Quad Cities Nuclear Power Station, Unit 1
Facility Operating License No. DPR-29
NRC Docket No. 50-254

Subject: Supplemental Information Supporting the Request for Technical Specification Changes for Minimum Critical Power Ratio Safety Limit

REQUEST FOR ADDITIONAL INFORMATION
RELATING TO REQUEST DATED 4/8/02 FOR CHANGE TO
SLMCPR EXELON GENERATION COMPANY, LLC QUAD CITIES NUCLEAR
POWER STATION, UNIT 1 DOCKET NO. 50-254

Figure 1

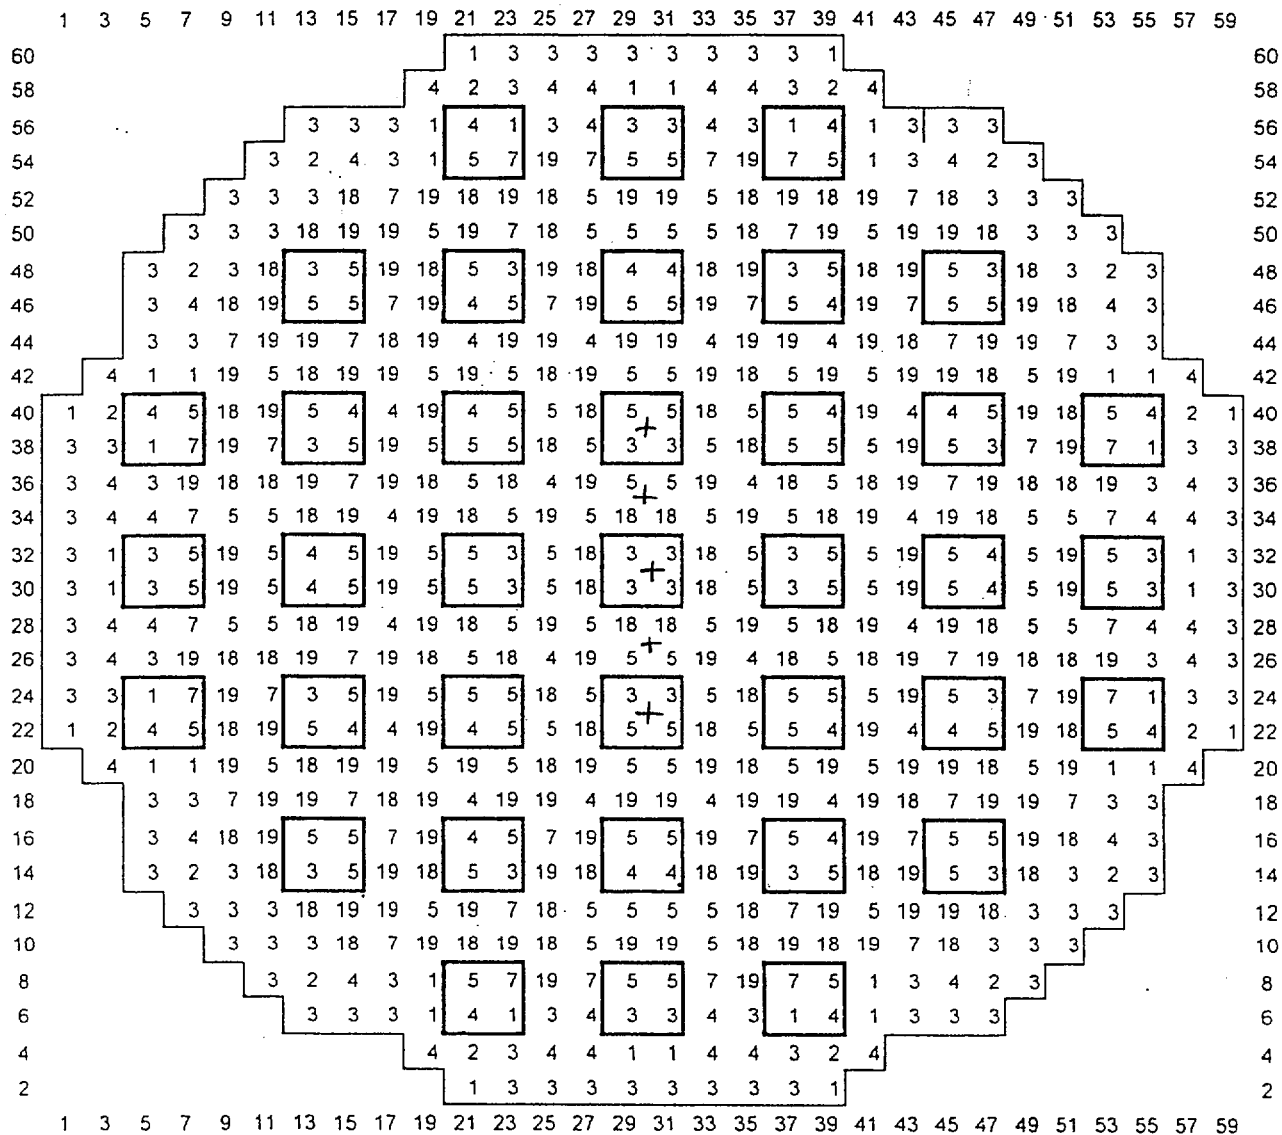
Please provide the core loading patterns for both before and after the mid-cycle fuel shuffle, including quantity, fuel type and when the bundles were loaded into the core, and identify the fuel type and quantity of the leaking fuel assembly.

Figures 1 and 2 respectively contain the Quad Cities 1 Cycle 17 and Quad Cities 1 Cycle 17A core loading maps. The table at the bottom of each figure identifies each fuel type in the core (GE10 – General Electric fuel type GE10, SPCA9 – Siemens Power Corporation fuel type ATRIUM-9B), the quantity of each fuel type contained in the core, and when each fuel type was first loaded in the core.

The leaking fuel assembly in Quad Cities 1 Cycle 17 was one (1) ATRIUM-9B assembly with 3.82 weight percent bundle enrichment and 12 gadolinium rods. This assembly is type 19 as identified in the tables and was first loaded in Cycle 17. It was replaced by one (1) GE10 assembly with 3.12 weight percent bundle enrichment and 7 gadolinium rods. This assembly is type 2 as identified in the tables and was first loaded in Cycle 14. This assembly had been discharged at the end of cycle 16.
